U.S. NUCLEAR REGULATORY COMMISSION
AUDIT REPORT NO. NRC-91-01

UNITED STATES GEOLOGICAL SURVEY
NEVADA TEST SITE & DENVER, COLORADO
SEPTEMBER 16-21, 1991

FIGURE NO. 1

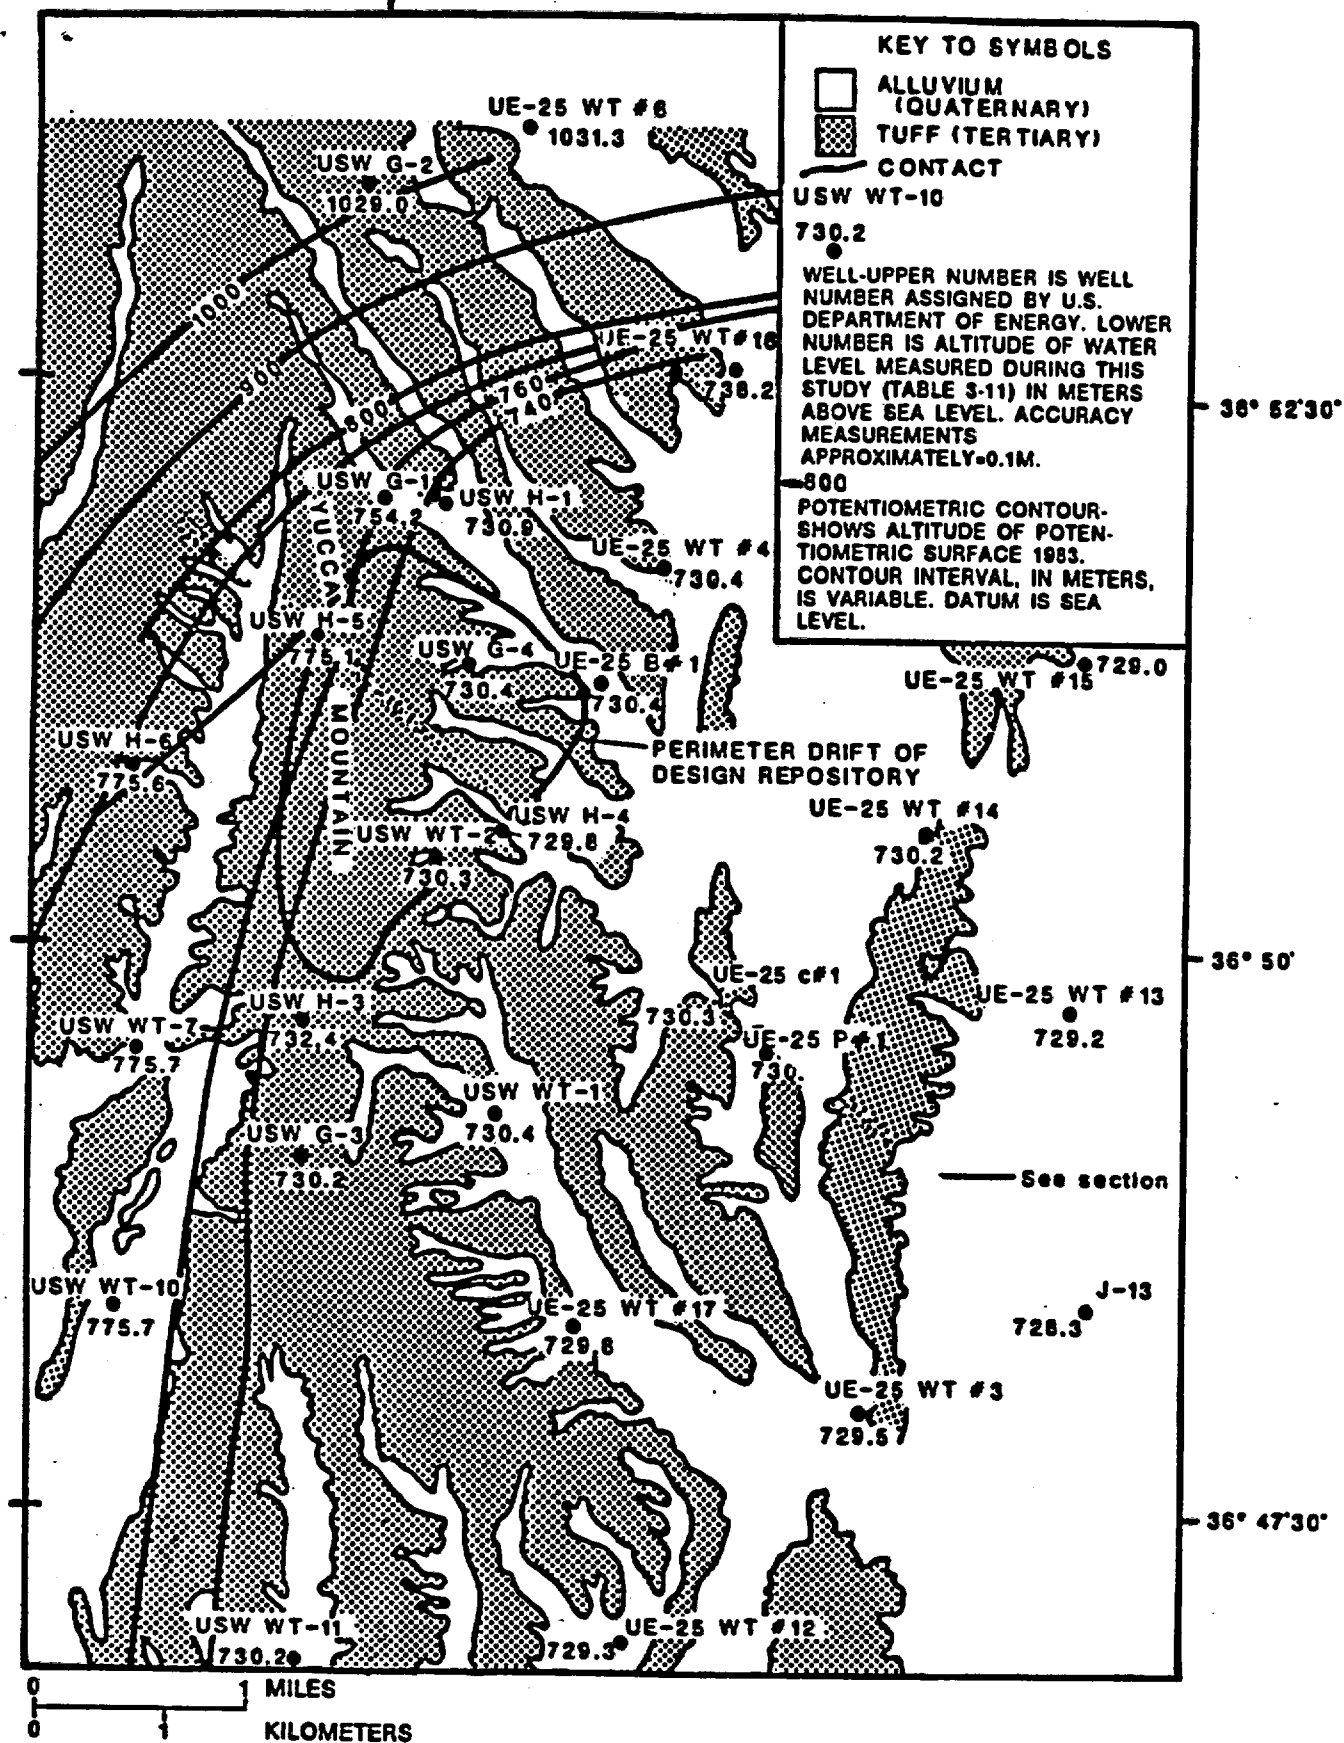
The NRC audit team visited two of the most distant well sites in the network of monitoring wells established by the YMP. These wells, USW WT-11 and USW H-6 which are located west of Yucca Mountain along branches of Solitario Canyon (See Figure No. 1) are outside the NTS. The audit team also visited well site UE-25 WT-16, located about one mile northeast of the repository site to observe the replacement of a transducer and the method used to measure the potentiometric level during calibration of the data recorder and transducer.
